Historical Architectural Review Board COA Preliminary Review Sheet

HDC-2024-00087

Address: 1118 Chew Street

Proposal: Vertical platform lift and porch overbuild.

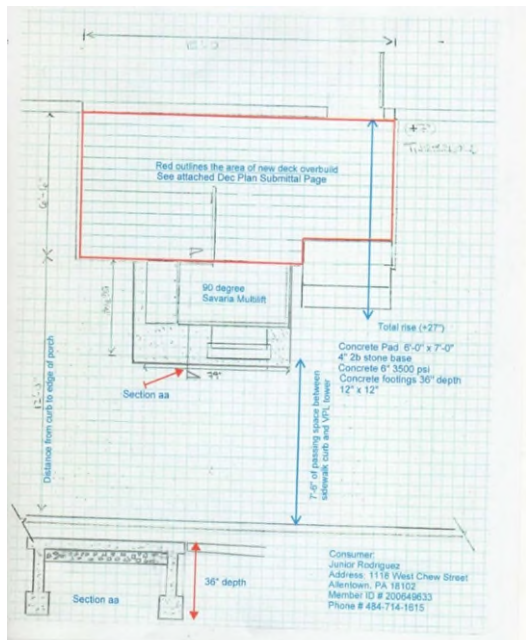
Providing an accessible entry at the primary entrance to the building is appropriate and recommended. The existing railing is called to be removed to accommodate the lift installation, and the applicant noted that the railing will be salvaged and reused. 1"x 4" pressure treated decking with dimensional framing below is proposed to raise the existing porch height to be in line with the doorway and lift. Guidelines Section 3.7.8 says "composite wood decking is an appropriate alternate to tongue and groove wood floors... Use of dimensional lumber for visible parts of a porch is not appropriate."

The proposed 1"x4" pressure treated decking would not be appropriate per the Guidelines. Salvaging and reinstalling the existing porch decking would be most appropriate. Alternatively, composite decking to match the original profile and dimension as closely as possible would be appropriate.

Reinstalling the existing railing is appropriate and maintains the historic character of the primary façade and porch. Reinstalling the railing to maintain the existing dimension from top of porch to top of railing would be appropriate.

- The existing porch decking is removed and reinstalled at the new raised height. Alternatively, composite decking to match the original in dimension as close as possible would be appropriate.
- The existing railing is reinstalled at the new raised height to maintain the existing dimension of railing height relative to the porch floor.

- A composite decking to match the original in dimension be installed without affecting the surrounding railings.
- The existing configuration and materials of railings outside the liftgate entrance be preserved.
- Any code-required handrail height adjustment be addressed through the installation of a simple, reversible handrail extension mounted to on the porch-side of the existing railing and be submitted for staff review and approval based on Guidelines Chapter 3, Section 3.7-Porches and Steps.
- The composite decking material sample submitted for review and approved by staff based on Guidelines for Historic Districts Chapter 3, Section 3.7-Porches and Steps.
